Addendum No. 03

PROJECT: PRESIDENT WOODROW WILSON HOUSE BUILDING SYSTEMS IMPROVEMENTS

DATE: JULY 27, 2026

RE: ADDENDUM NO. 3 TO REQUEST FOR PROPOSAL 2026-09, ISSUED JULY 6, 2026

1
M-601 NTS CONDENSATE RISER DIAGRAM 1

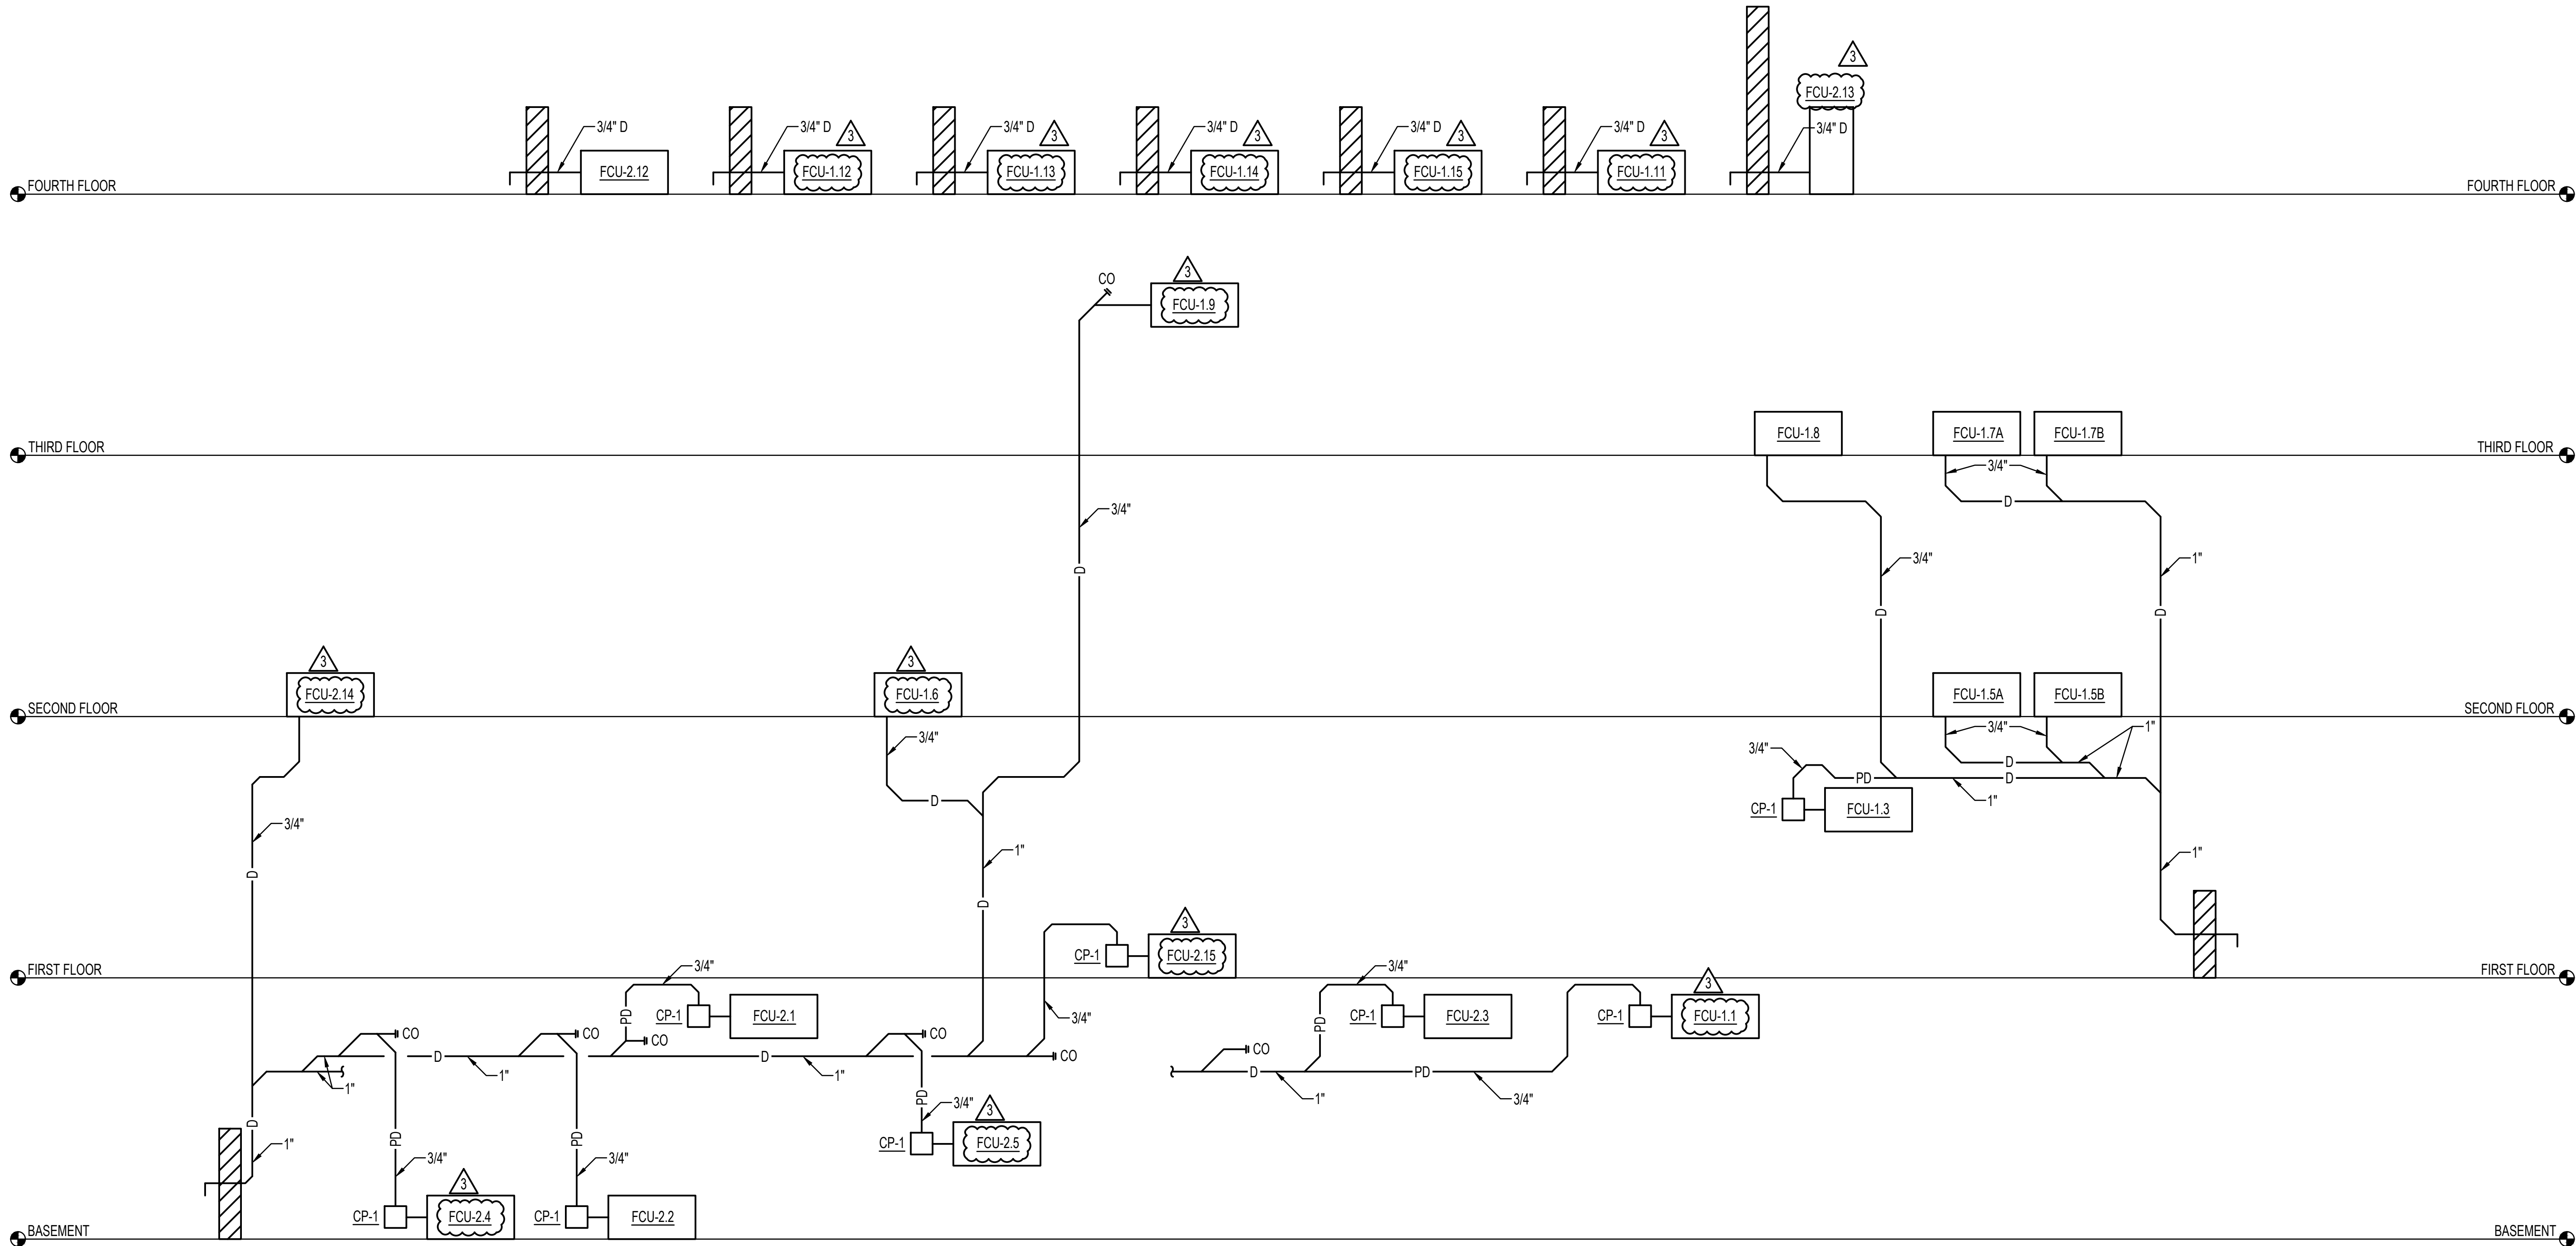
5. SHEET M-104 FOURTH FLOOR – MECHANICAL – NEW WORK
 - a. Update FCU designations per revised sheet.
 - b. Updated HPU-1 and HPU-2 footprint as noted.
6. SHEET M-601 CONDENSATE RISER DIAGRAMS

- a. Update FCU designations per revised sheet.
7. SHEET M-602 CONDENSATE RISER DIAGRAMS
 - a. Update FCU designations per revised sheet.
8. SHEET M-801 MECHANICAL SCHEDULES
